**COUNTY OF SAN MATEO
PLANNING AND BUILDING DEPARTMENT**

SUBJECT: EXECUTIVE SUMMARY: Consideration of a Coastal Development Permit and Design Review Permit, pursuant to Sections 6328.4 and 6565.3 of the San Mateo County Zoning Regulations, respectively, to allow construction of a new 4,742 sq. ft. two-story single-family residence, plus a 651 sq. ft. attached garage, subsequent to the demolition of the existing residence, on a legal 10,548 sq. ft. parcel. No significant trees are proposed for removal and only minimal grading is involved. The project is appealable to the California Coastal Commission.

County File Number: PLN 2016-00317 (Reilly)

4 ENCLOSED ROOF DECK - PROPOSED
(SOUTH ELEVATION, NORTH SIMILAR)

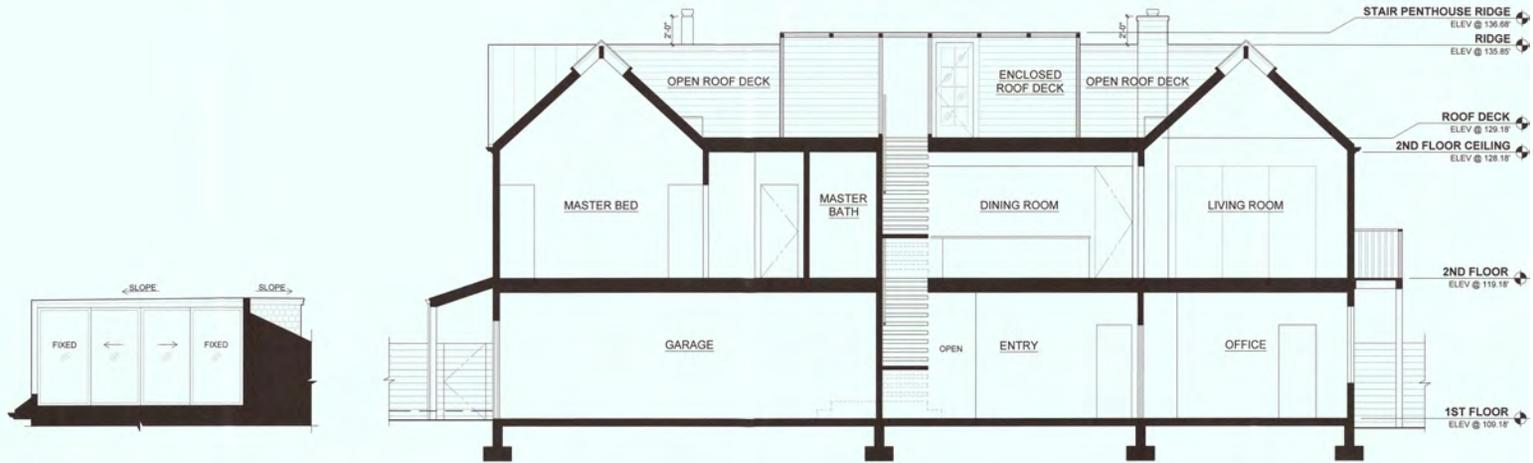
- a. Lower the height of the covered glass roof deck to equal or less than the adjacent gable height.
 - b. Recommendation: Remove the roof and side doors on the covered glass roof deck.
